MEMORANDUM

Project: Molalla Avenue Streetscape Project

Subject: Gaffney Lane Neighborhood Association Comment Letter Response

This memorandum is to address the project comments from the Gaffney Lane Neighborhood Association dated April 30, 2019.

Figure 1 - Southridge Shopping Center Access Points

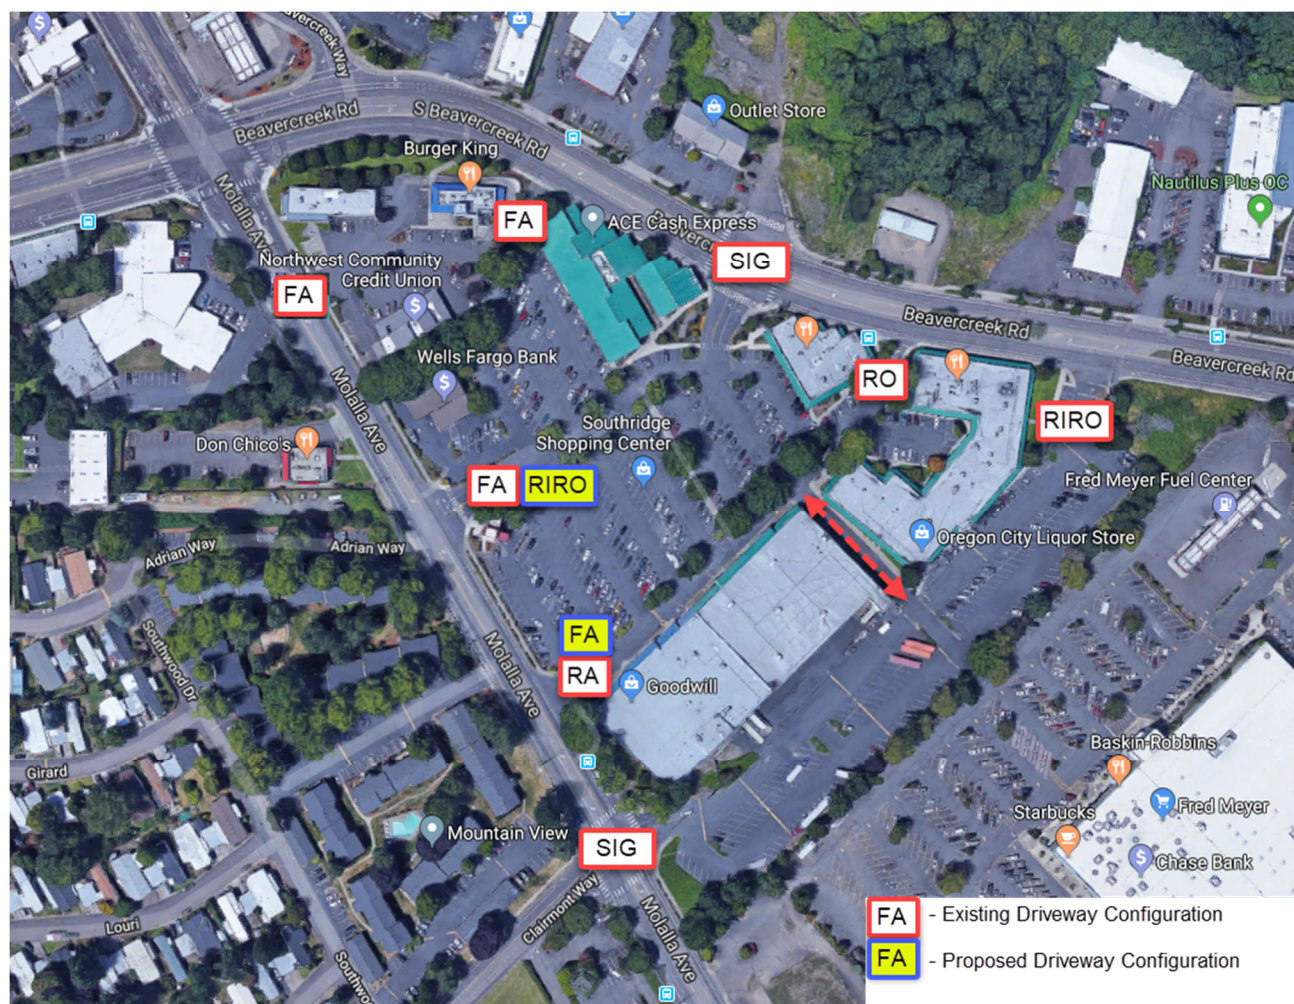
We would like clarification on the proposed traffic flow in and out of this business development. Current plans only indicate access either from Beavercreek or the intersection at Clairmont for south bound traffic.

Response: The challenge with allowing the southbound left-in at the proposed right-in/right-out driveway is that the anticipated northbound left-turn queues from the signal at Beavercreek Road will likely extend beyond this driveway. There is also insufficient space to accommodate back-to-back left-turns (i.e., northbound for Beavercreek Road signal and southbound into driveway) under existing and future traffic volume conditions. This will result in southbound left-turns stopping in the through lane introducing other safety issues along Molalla Avenue. The developments in the southeast quadrant of the Beavercreek Road/Molalla Avenue intersection will continue to have several opportunities to complete all movements with limited additional travel distance via an existing signal on Beavercreek Road, two right-in/right-out accesses (including proposal), and two full access driveways, refer to **Figure 1**.

Exhibit 1 – Molalla Streetscape Project Overall Project Map

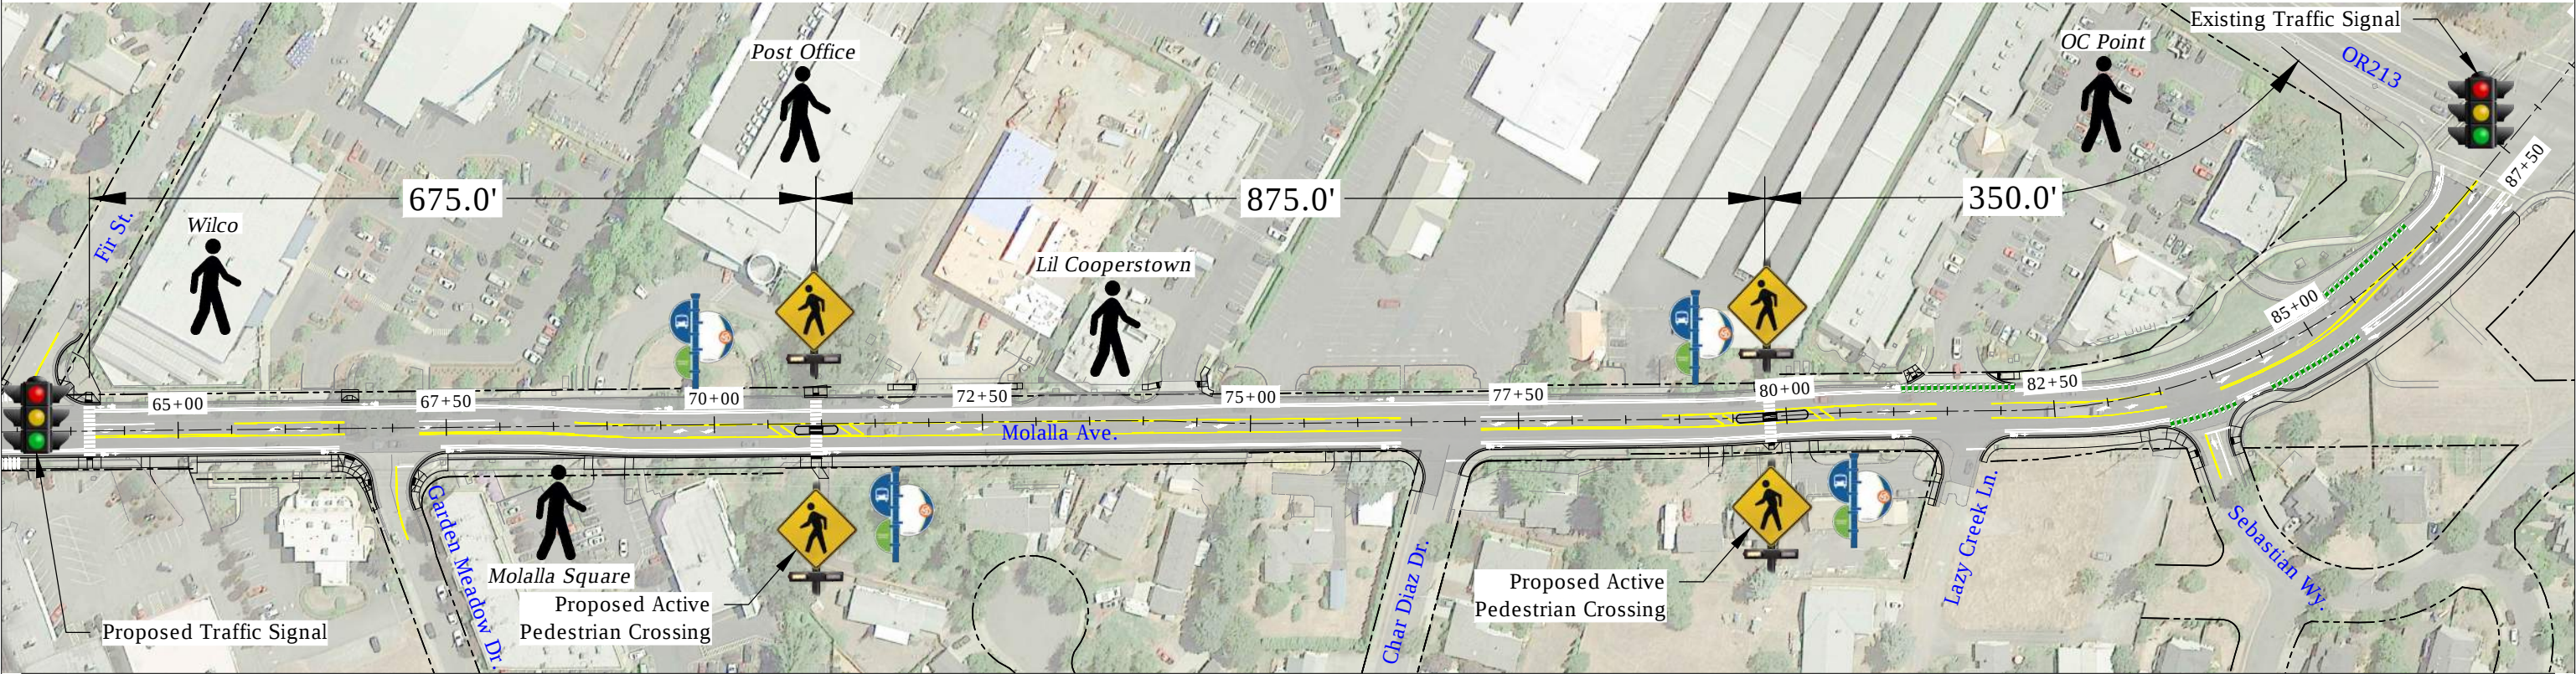
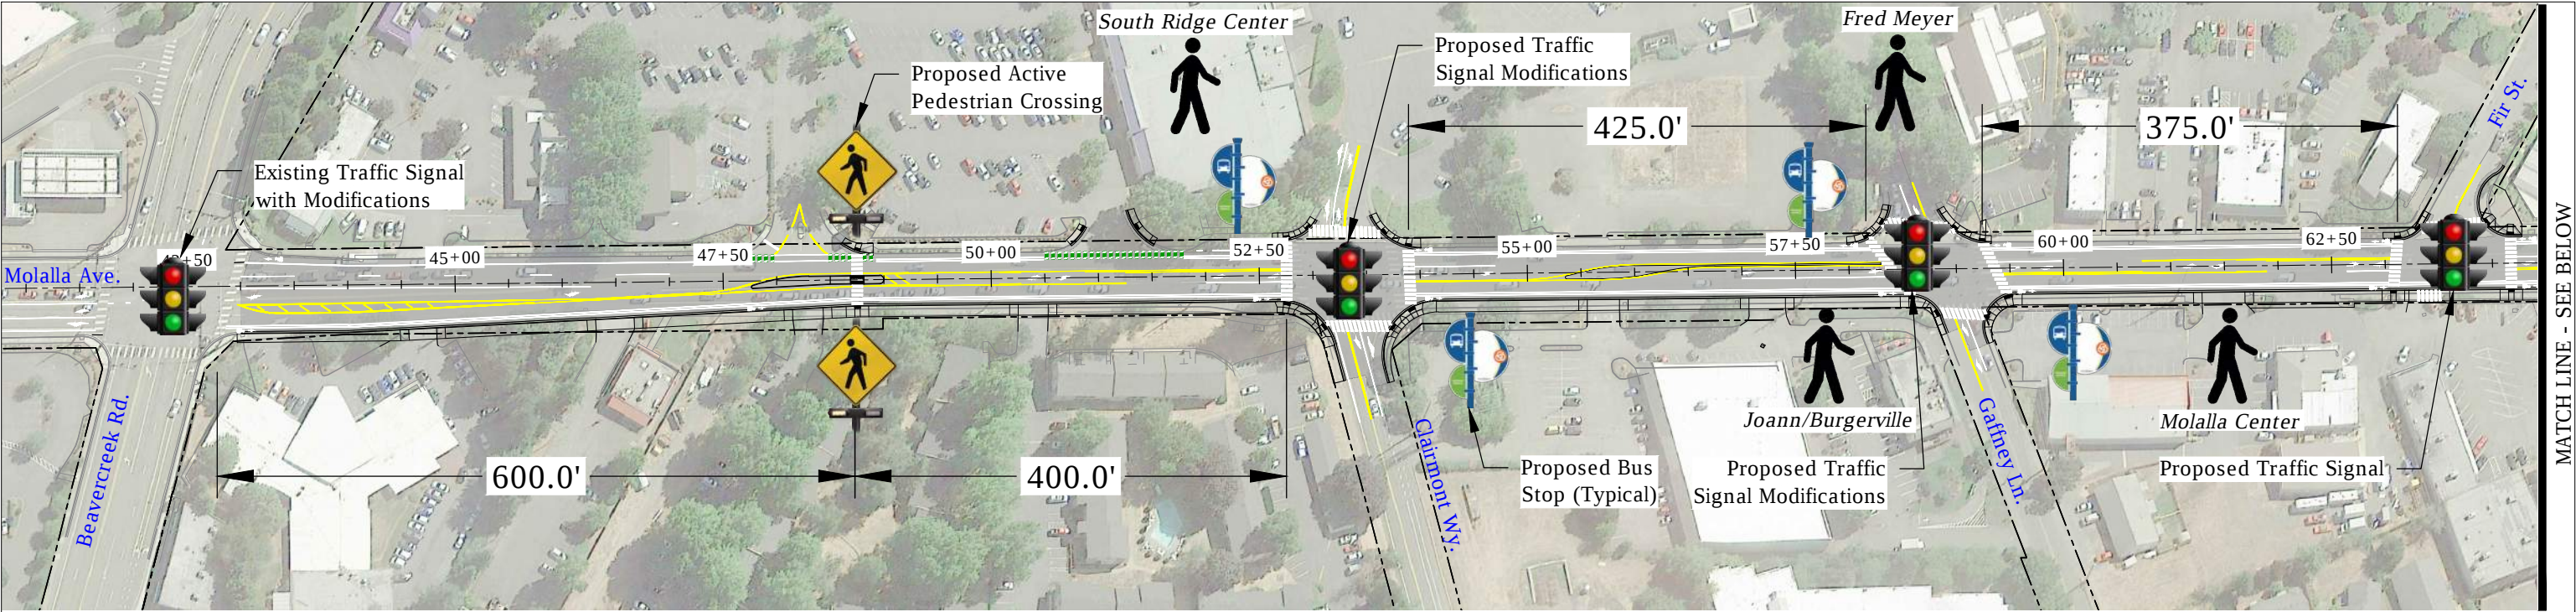
We would like to see designated turn lanes and signals at this intersection, similar to the ones proposed at Gaffney and Molalla. The pedestrian crossing at this intersection currently impedes left turns and we would recommend designated left turn signals that do not coincide with pedestrian crossing. We believe we were told the study warranted designated turn lanes here.

We would like to see the bus stops remain at this intersection. The residents of the apartments use these stops regularly.

We are in support of the proposed change to signal phasing and lane reconfiguration, to create designated left turn lanes that would not conflict with the straight and right turn movements. (since at least 2013 we have been asking for this light to be adjusted. It is unsafe to have the cars coming from Gaffney turning left and going straight at the same time as the cars coming from Fred Meyer are going left and straight. We have asked to have a designated turn signal here and have been assured that this was in the works. We realize things change but in an email from John dated February 10, 2013 he stated changes to this signal would be made in that budget cycle as it was agreed it was a safety concern. It's been over six years and it has only gotten worse.)

We would like to see the bus stops remain at this intersection as they are heavily used by patrons of Fred Meyer.

Response: The signal phasing and project design has been updated to provide separated and protected left-turn movements, this also removes the pedestrian walk conflict from the left turn movements. The lane assignments are shown in Exhibit 1.

Response: Bus stops will remain at the intersection and be located downstream of the signal in each direction, refer to Exhibit 1.

Response: The signal phasing and project design has been updated to provide separated and permissive/protected left-turn movements; this also removes the pedestrian walk conflict from the left-turn movements. The lane assignments are as shown in Exhibit 1.

Response: Bus stops will remain at the intersection and be located downstream of the signal in each direction, refer to Exhibit 1.
